## The Price Display – Case Design Changes – Back panel only part 2

Pic 1: Back of case with circuit board inside. Note bottom right in pic is open.

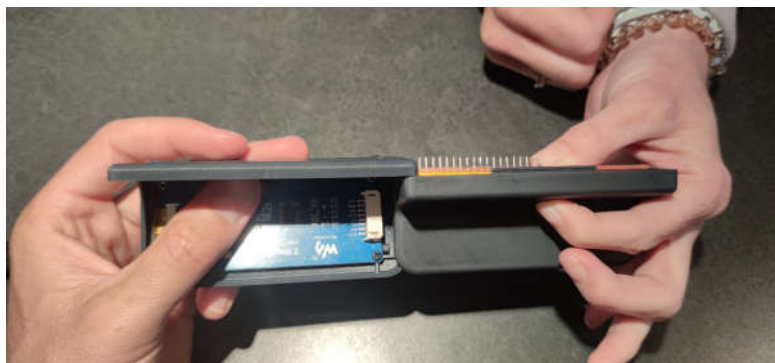
5. The case doesn't fully close as the pins on the board do not have enough space.

Pic 2A&B: I have lined up the two halves. See how the pins protrude past base of top case.

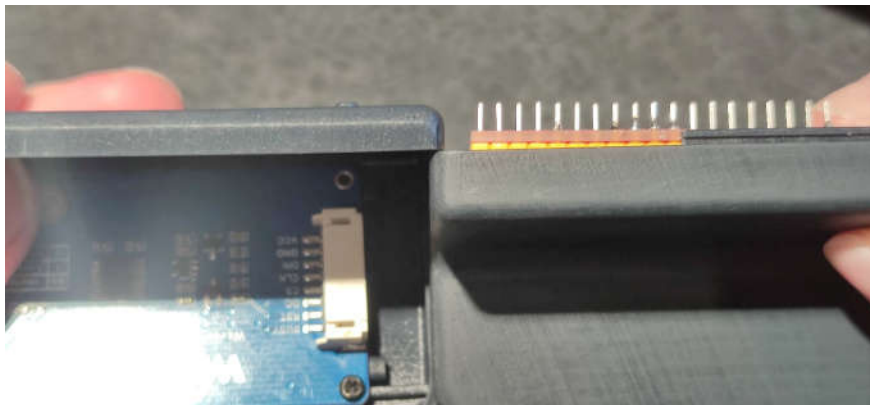
**Pic 3:** When USB Port lined up, the distance from the back case top to bottom of pins was 16.5mm

**Pic 4**

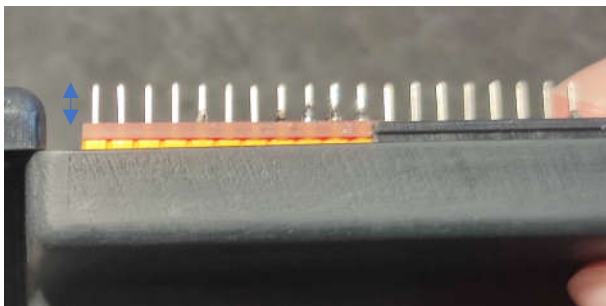
- Length of pin below red board: 4.2mm (see pic 4)
- Width from top of Chip to bottom of red board = 9.1mm (see pic 5)
